# Montgomery County Historic Preservation

## Staff Report

<p><b>ADDRESS:</b> 19 High St., Brookeville</p> <p><b>RESOURCE:</b> Brookeville Historic District</p> <p><b>APPLICANT:</b> 19501 Georgia, LLC (Luke Olson, Architect)</p> <p><b>REVIEW:</b> HAWP</p> <p><b>CASE NO.:</b> 867436 REVISION 4</p> <p><b>PROPOSAL:</b> Revisions to Previously Approved HAWP</p>	<p><b>MEETING DATE:</b> 6/10/2026</p> <p><b>REPORT DATE:</b> 6/3/2026</p> <p><b>PUBLIC NOTICE:</b> 5/27/2026</p> <p><b>TAX CREDIT ELIGIBLE:</b> No</p> <p><b>STAFF:</b> Dan Bruechert</p>
--	---

Figure 3: The approved design (left) and revised rear porch (left).

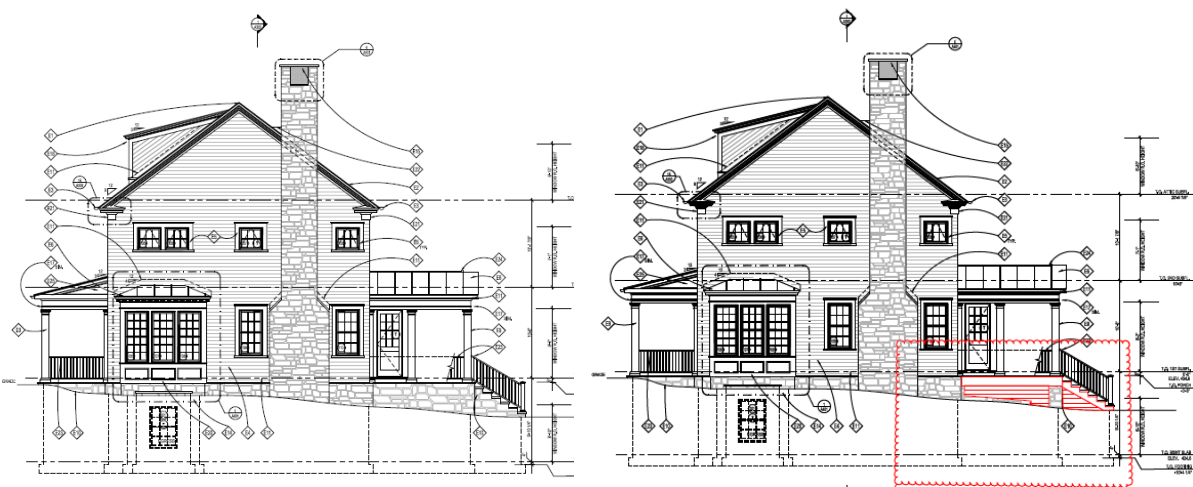
The approved rear porch design included flagstone stairs on a concrete base, and for the stone veneer foundation to extend around the porch. The applicant proposes to revise the porch design so that the stairs and decking are constructed using Acre composite decking with wood risers, trim, and skirtboard. The concrete piers in the corners will be covered in stone veneer that matches the house foundation. Staff finds, from a design perspective, that wood stairs, decking, and skirting are compatible with the architectural character of the house’s Colonial Revival design. While wood is the historically appropriate material, the *HPC Porch Flooring Policy* prescribes when a substitute material is acceptable. Based on this policy, because the subject property is a ‘Spatial’ resource within the historic district, and because the porch is on the rear of the house in a location that is not at all visible from the right of way, a substitute material may be used. In fact, based on the level of designation of the site, the material does not even need to satisfy the higher-level criteria for a ‘compatible substitute material,’ though Acre decking is millable, paintable, has a minimal texture, and has a finished edge. Finally, Staff finds the treatment of the proposed piers is compatible with the character of the house and, as an element not visible from the right-of-way, should be given a lenient review under 24A-8(d) and complies with the *HPC Porch Flooring Policy*.

Figure 4: the proposed areaway footprint and landing are shown in the upper left corner of the floorplan.

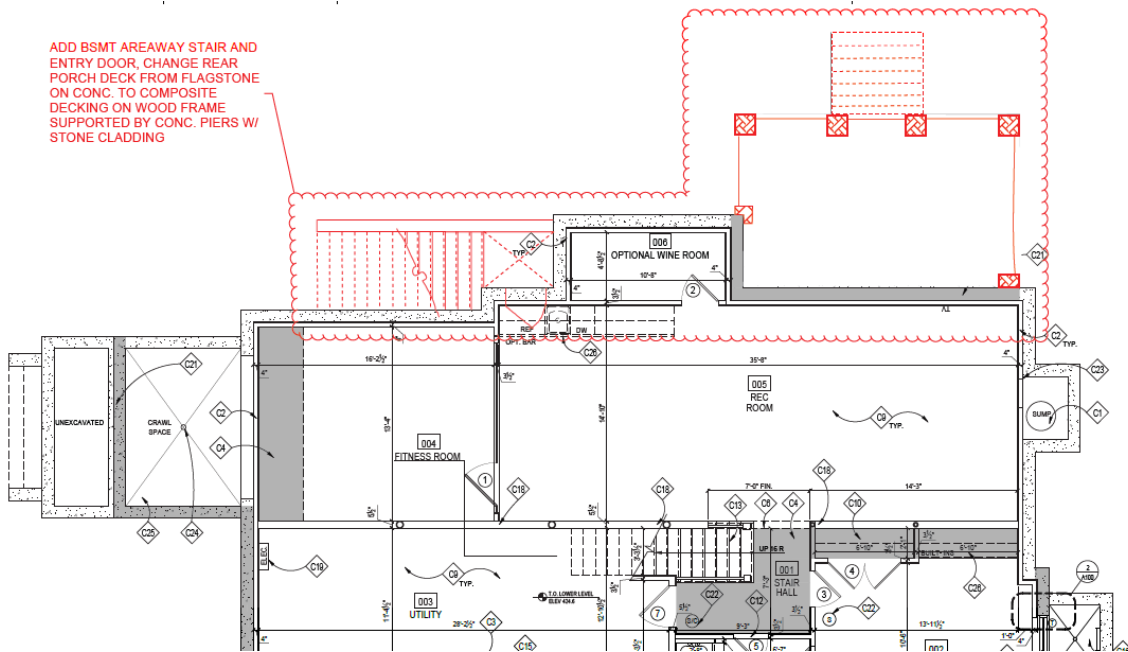
Staff finds the proposed areaway’s location, at the rear, will not have a substantial impact on the character of the site and will not be visible from the public right-of-way. Staff further finds that the concrete stairs and walls are compatible materials for the feature. Because there is not a detailed specification for the proposed door, and because the HPC has previously found a clad door to be

appropriate at this house, Staff recommends the HPC add a condition to the approval of this HAWP revision requiring the submission of detailed door specifications before the issuance of the final HAWP approval documents. Final approval authority can be delegated to Staff. Because of the height of the drop, Staff also suspects that a railing will need to be installed around the areaway to satisfy code. Staff recommends the HPC add a condition to the approval of this HAWP that requires a wood or metal railing if necessary to satisfy code. Final approval authority for this railing can be delegated to Staff. With the two recommended conditions, Staff finds the proposed areaway is compatible with 24A-8(b)(2), (6), and (d); and *Standard #2*.

1. Detailed railing specifications around the areaway must be submitted before the release of the HAWP approval documents;
2. Detailed door specifications for the new basement entrance must be submitted before the release of the HAWP approval documents;

**1 REAR ELEVATION**  
SCALE: 1/4"=1'-0"

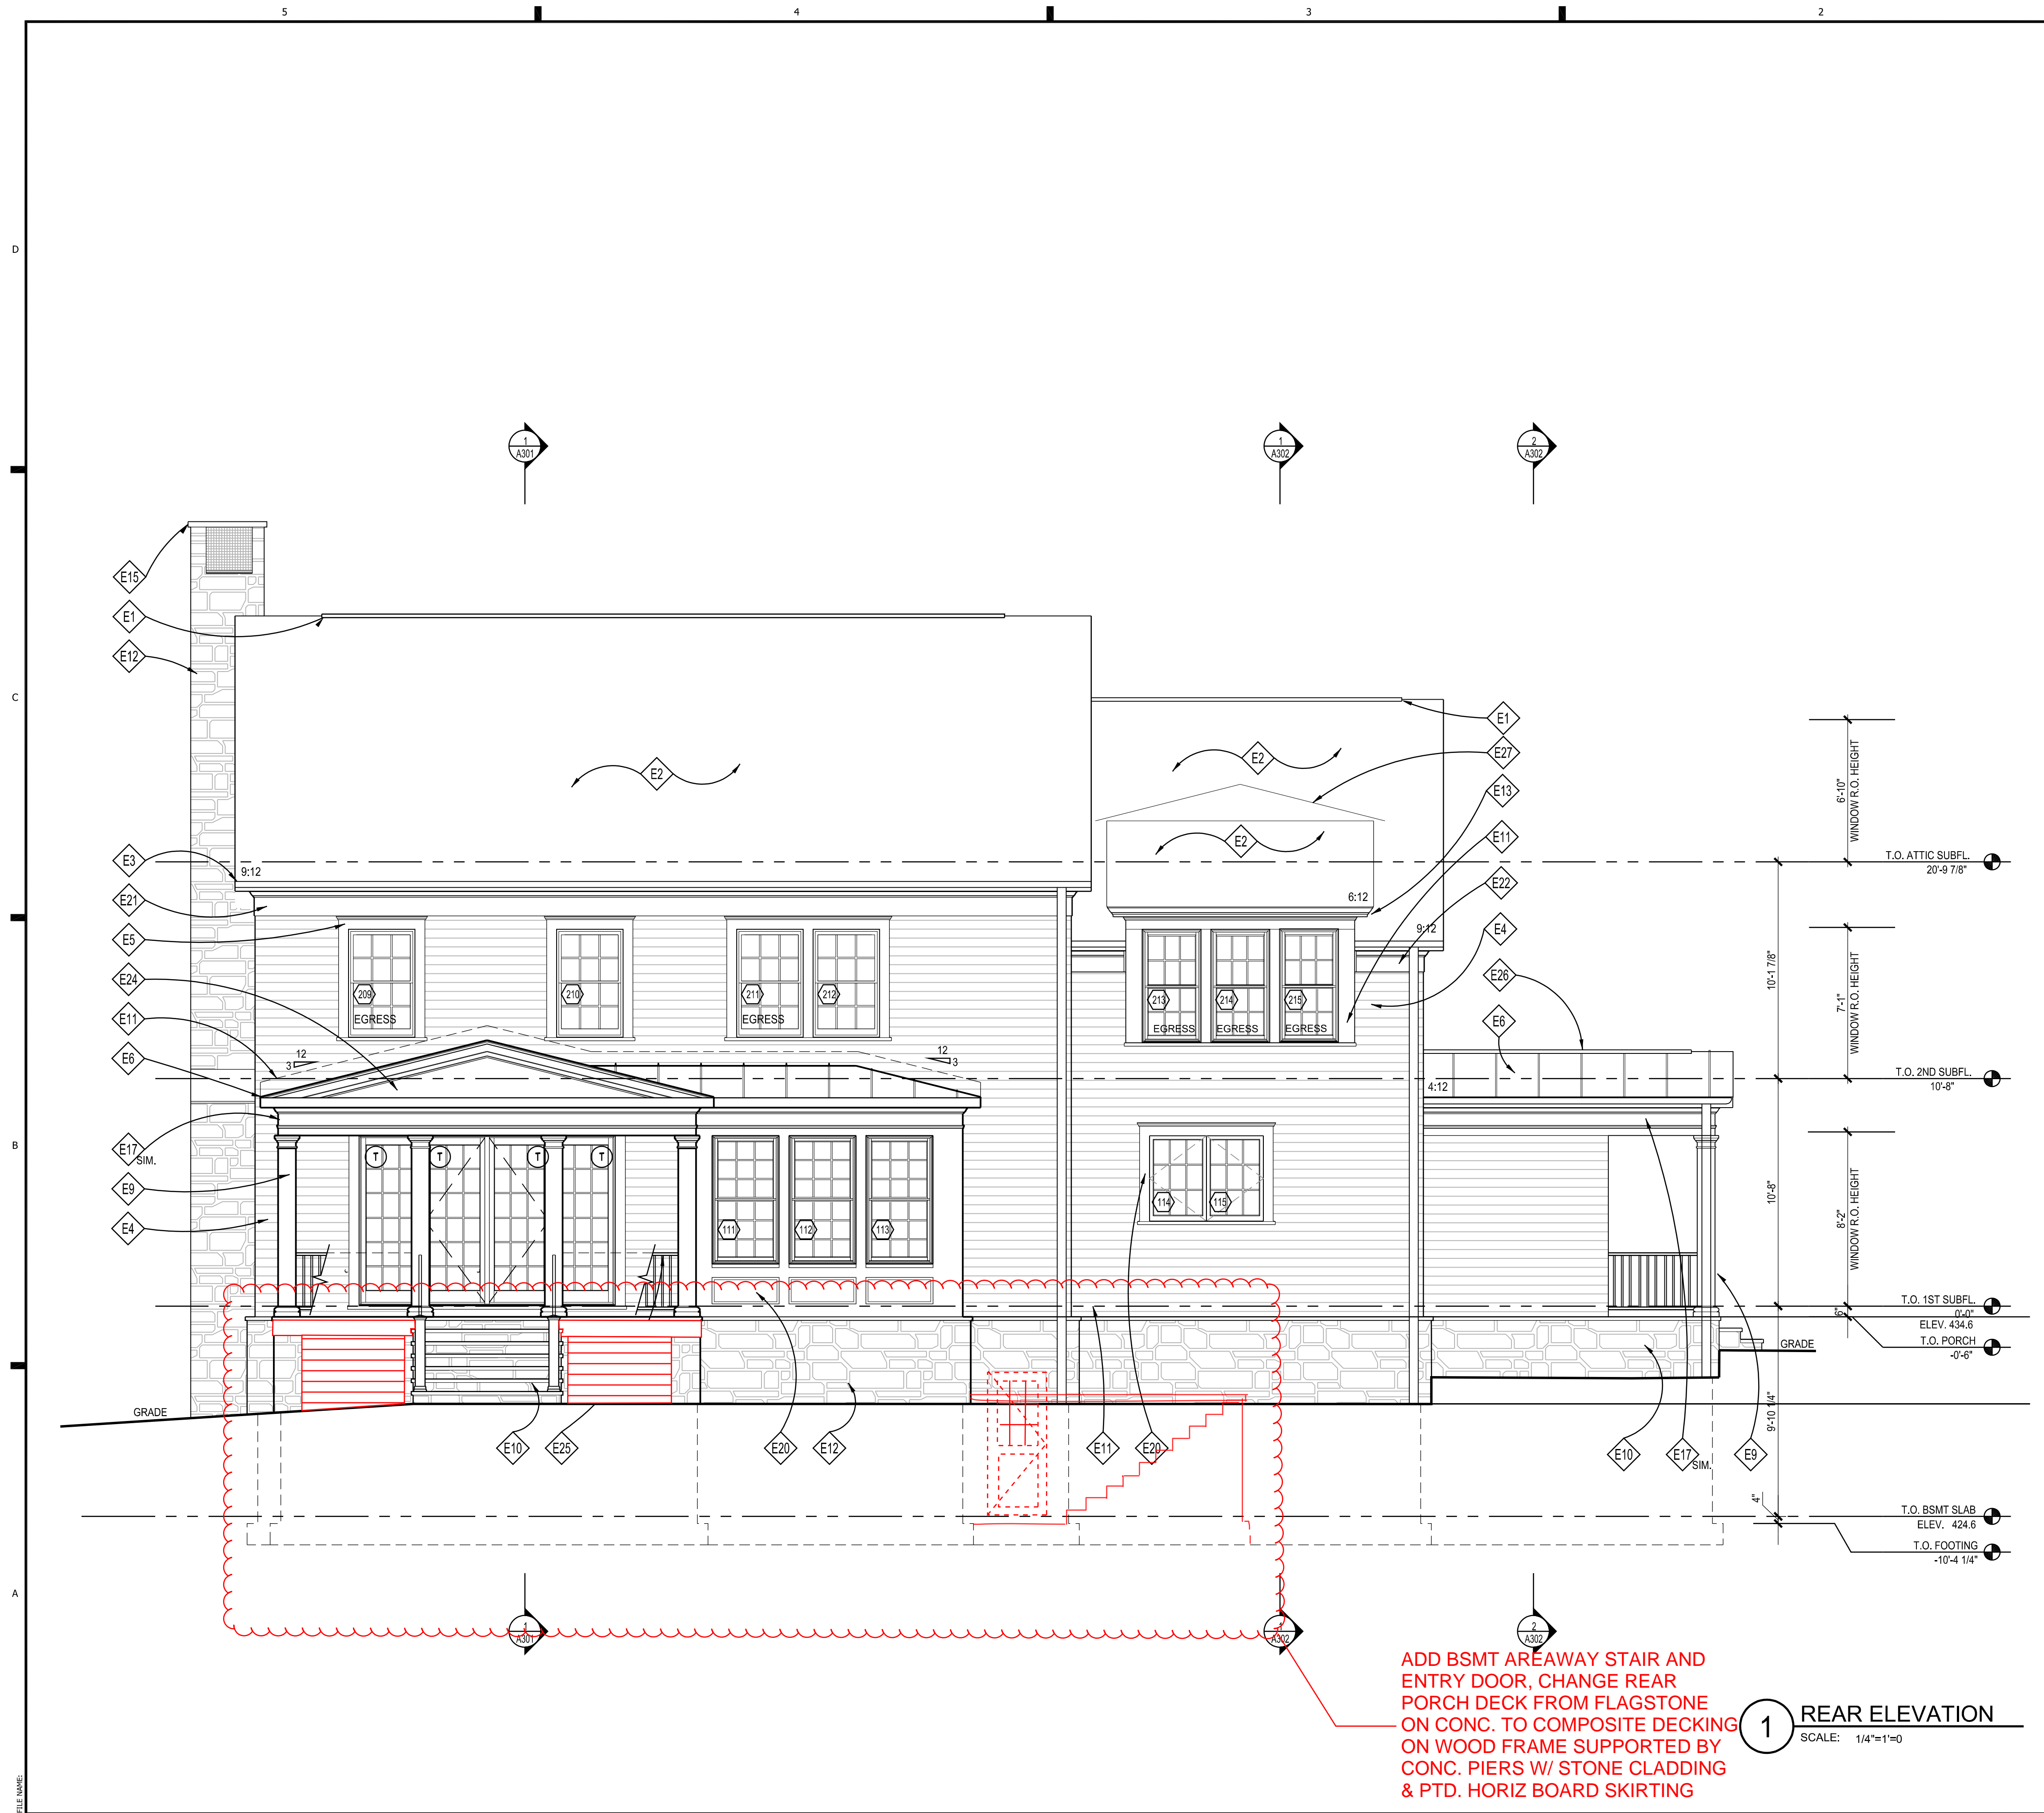
ADD BSMT AREAWAY STAIR AND ENTRY DOOR, CHANGE REAR PORCH DECK FROM FLAGSTONE ON CONC. TO COMPOSITE DECKING ON WOOD FRAME SUPPORTED BY CONC. PIERS W/ STONE CLADDING & PTD. HORIZ BOARD SKIRTING

**1 LEFT SIDE ELEVATION**  
SCALE: 1/4"=1'-0"

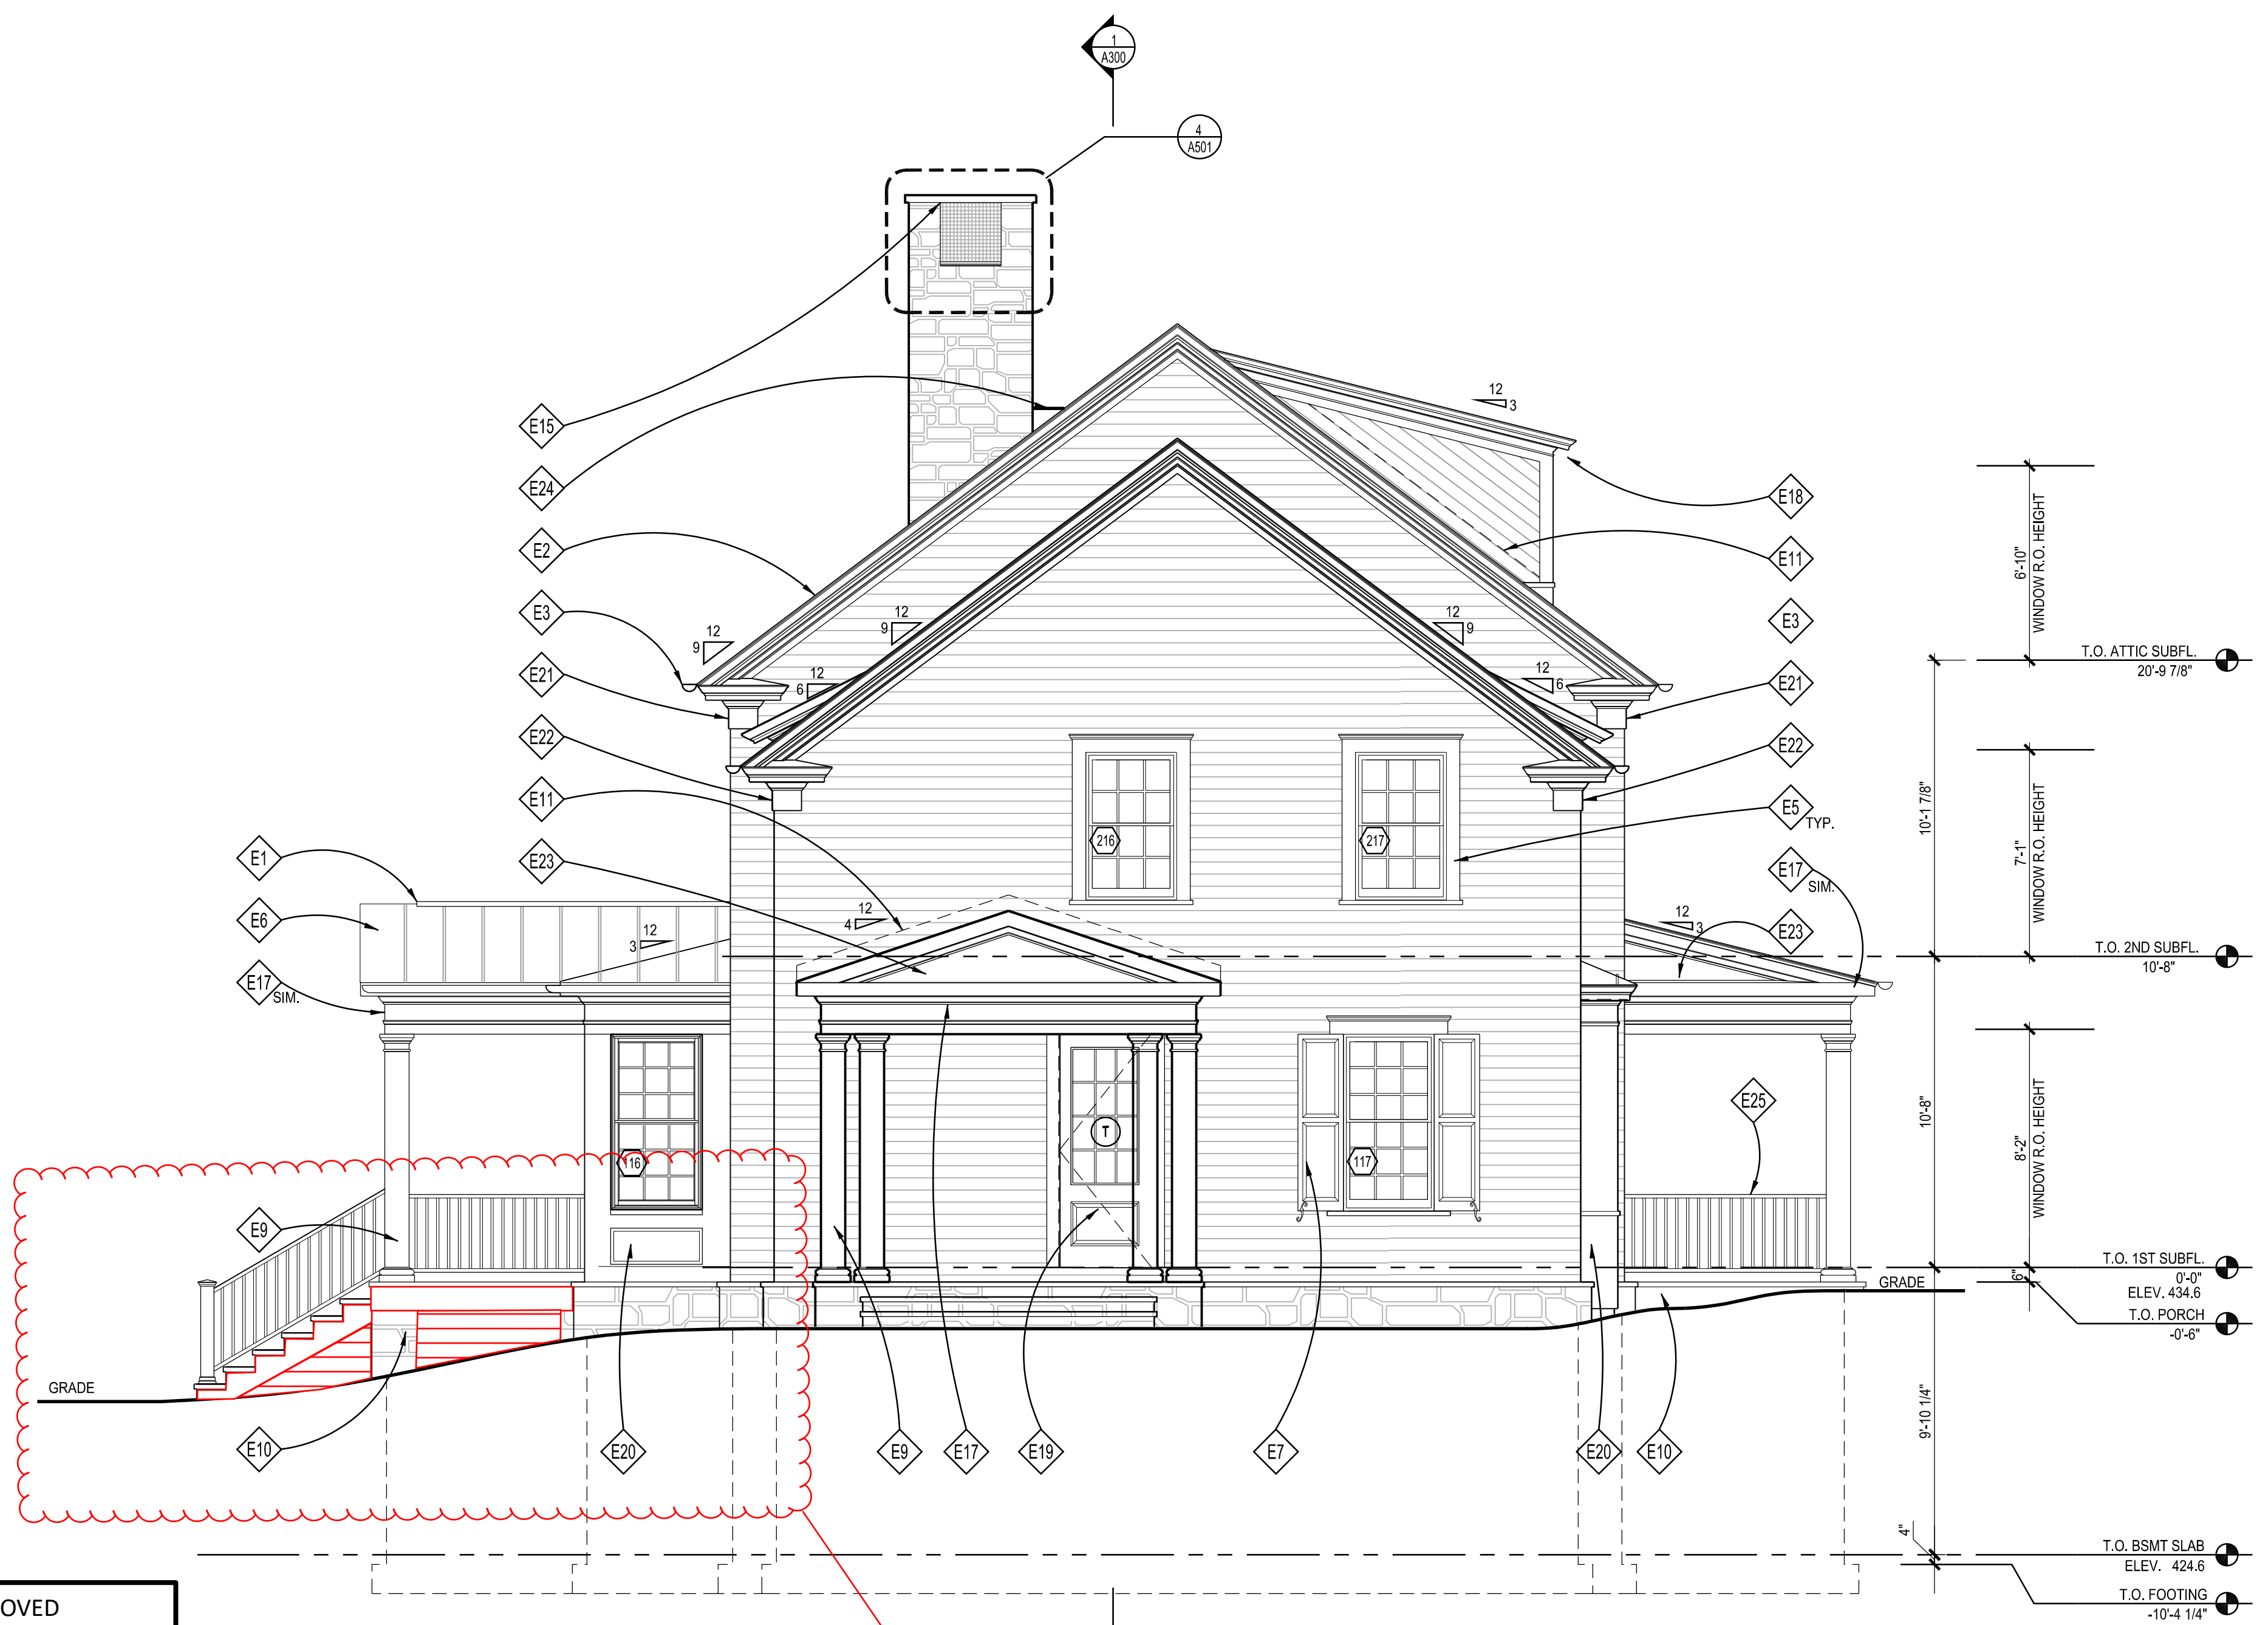
**CHANGE REAR PORCH DECK FROM  
FLAGSTONE ON CONC. TO  
COMPOSITE DECKING ON WOOD  
FRAME SUPPORTED BY CONC.  
PIERS W/ STONE CLADDING & PTD.  
HORIZ BOARD SKIRTING**
